Northeast Corner @ Thomas

J/P 32746(04) and J/P 33232(04)
 SPECIAL DETAIL
 ramp at NE corner of Thomas

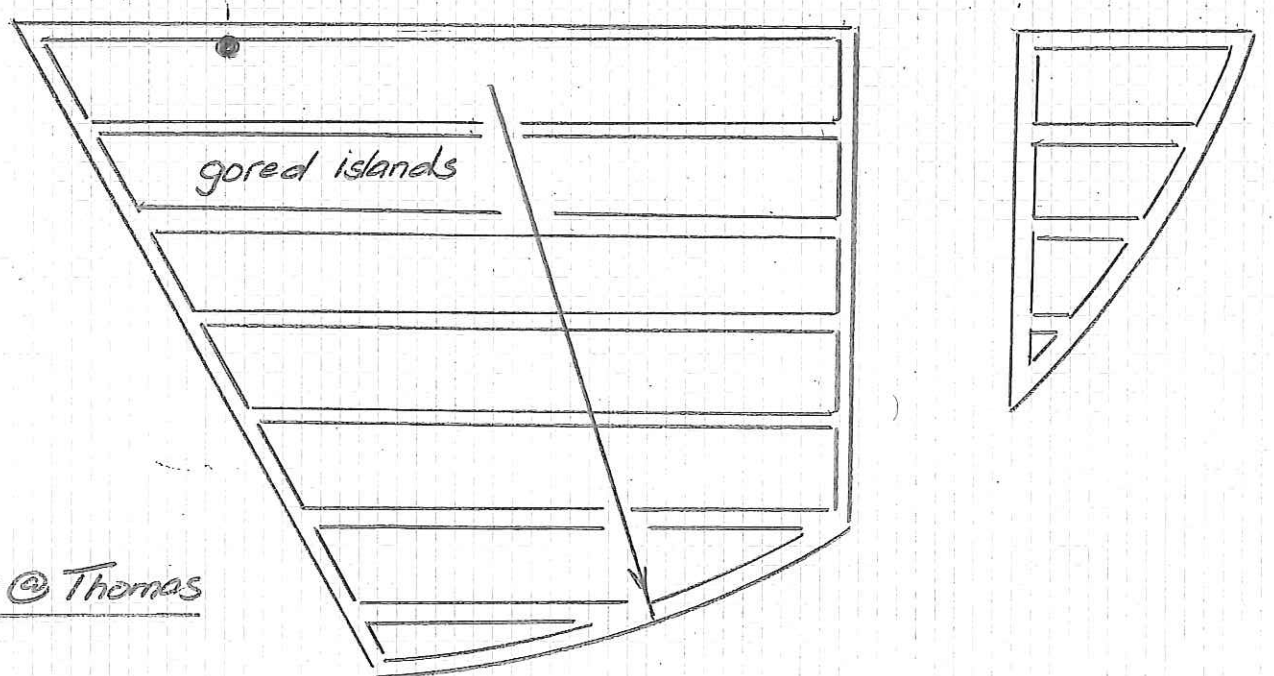
note: This door is high & will not be flush w/ platform. But it's a secondary door never used.

If necessary, replace this slab to be flush w/ ramp.

Replace apron w/ conc.; maintain gutter flow to the south.
